Subject: Arkansas Nuclear One - Unit 2  
Docket No. 50-368  
License No. NPF-6  
Additional Information Regarding The ANO-2 Deterministic Operational  
Assessment Of Steam Generator Tubing For The Remainder Of Cycle 14

**ENTERGY OPERATIONS DISCUSSION OF NRC COMMENTS IN  
MAY 2, 2000 LETTER**

**Figure 1**

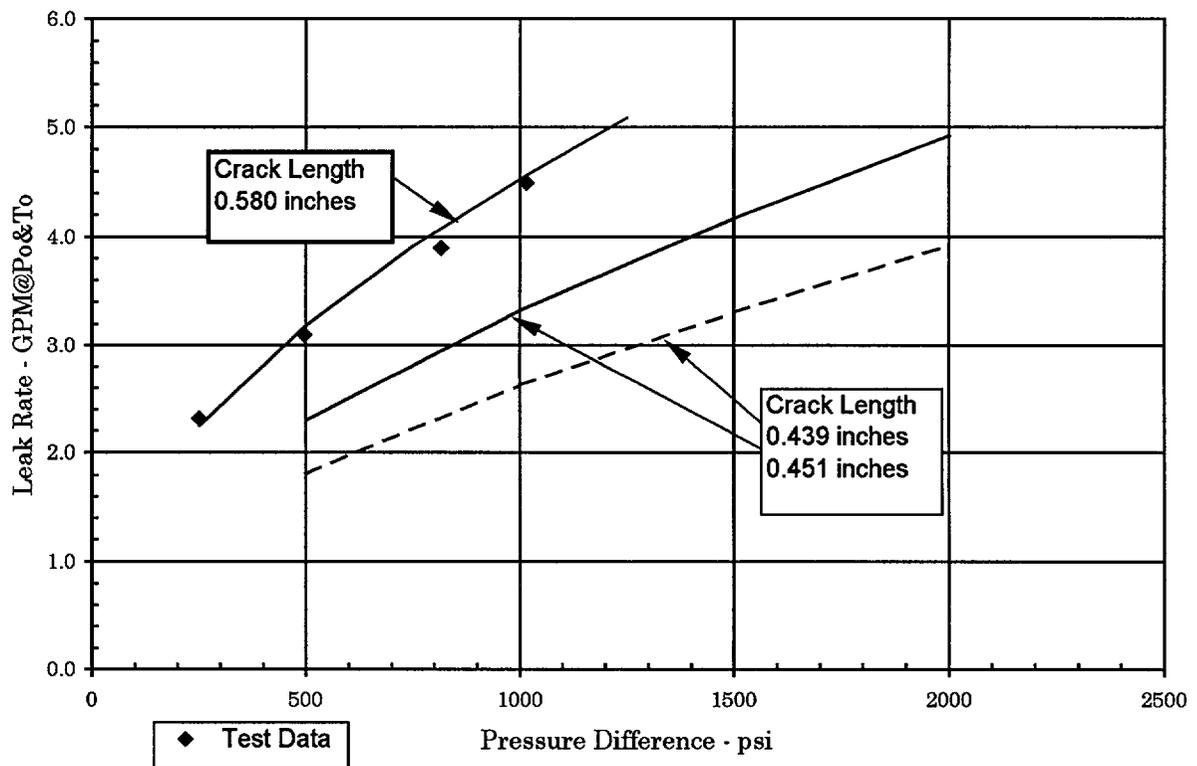
The NRC applied the same burst prediction model to the post-test plus-point profile. The calculated burst pressure is 1933 psi with the WCAP-15128 model. This is consistent with the hypothesis that the crack was at the point of incipient total ligament failure and incipient burst at the time the test was terminated, and that the crack had undergone significant ligament damage and degradation of its subsequent burst pressure capability.

Analyses were performed of the leak rate measurements performed following the peak pressure of the in-situ test. Leak rates were measured up to about 1015 psi (1700 psi corrected for flow) where the leak rate again reached the test equipment limit of about 4.5 GPM. The pressurization to 4147 psi results in a plastic opening of the crack that dominates the post peak pressure leak rates. For the analyses, plastic crack openings were calculated using the CRACKFLO model for various through-wall crack lengths for which the leak rate exceeded 4 GPM at 4147 psi. These plastic openings were then used to calculate the post peak pressure leak rates. Figure 1 shows the predicted leak rates versus pressure for through-wall lengths of 0.439, 0.451, and 0.580 inches, along with the measured values from tube 72-72 (noted as test data). It is evident that a through-wall length of 0.58 inch yields agreement

with the measurements. Consequently, the ligament tearing of tube 72-72 at peak pressure was approximately 0.58 inches and not the total crack length. If the through-wall length was much longer, the post peak pressure measurements could not have reached approximately 1000 psi for a 4.5 gpm leak rate. This result demonstrates modest ligament tearing and that the indication would have a significantly higher burst pressure than the ligament tearing pressure in the test of 4147 psi.

**FIGURE 2**

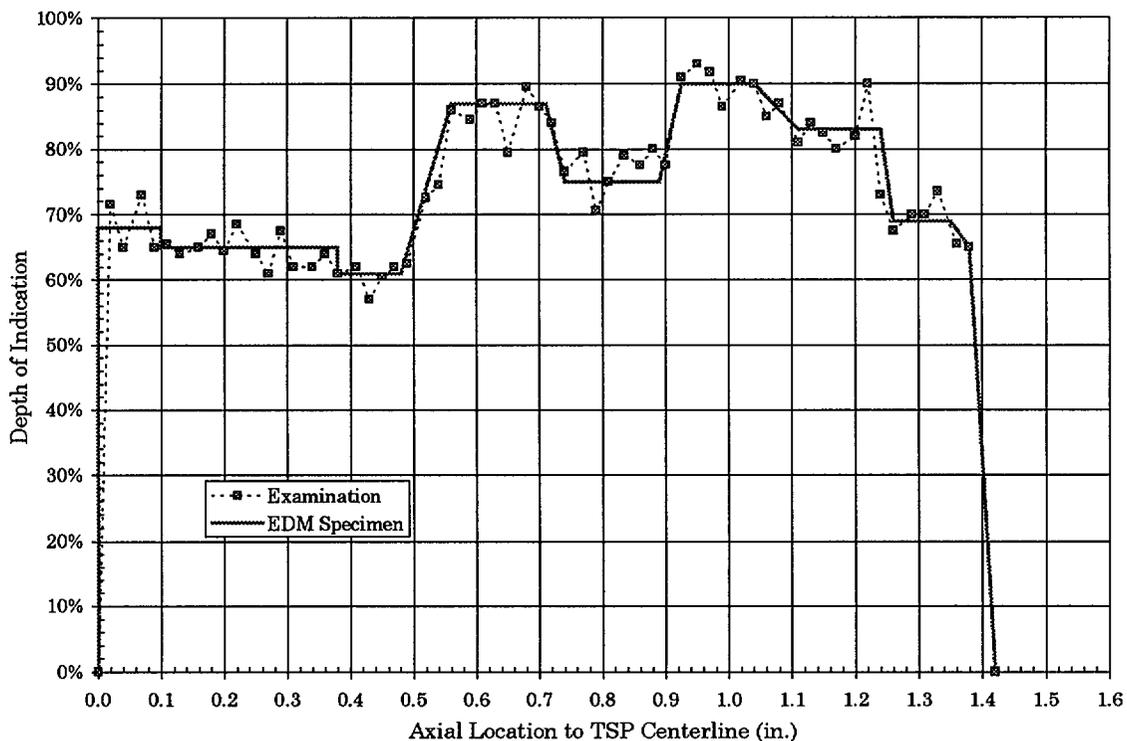
The electric discharge machine (EDM) notched samples contained 80% TW EDM notches with lengths of 0.5 inches and 0.7 inches. These samples appear non-representative of the likely pre-test crack profile, as discussed in item 7 above, and do not provide a credible basis for evaluating the pressure differences between ligament failure and burst.

Batteries of leakage/pressure tests have been conducted to estimate the burst pressure of tube 72-72. These tests were performed by electrical mechanical discharge (EDM) cutting of flaws into representative samples of 3/4 inch Inconel 600 tubing. These flaws were then pressurized to determine their leakage characteristics and burst pressure. Initially, five samples were cut to replicate profile S5971 as shown in Figure 2. These samples were then pressurized. Each of the samples failed without indication of prior leakage. The adjusted failure pressure was, on average, recorded at approximately 2500 psi. These results clearly indicated the actual flaw in tube 72-72 was substantially smaller than that depicted by profile S5971. This was not totally unanticipated given the propensity for eddy current to oversize the average depth of axial flaws based on pulled tubes.

A subsequent battery of tests were performed varying the depth of the flaw while maintaining the overall flaw length and characteristics as indicated by pre-in-situ eddy current examination of tube 72-72. The test results did not simulate the leak rates and pressures seen during the in-situ pressure test of tube 72-72. Without advance leakage, these flaws opened significantly longer than that of the flaw in tube 72-72, as indicated by the inability to repressurize the tube. Leakage calculations show that the increased leakage from tube 72-72 during the final stages of the in-situ pressure test was most likely due to the tearing open of an approximate 0.58 inch long deep segment of the flaw.
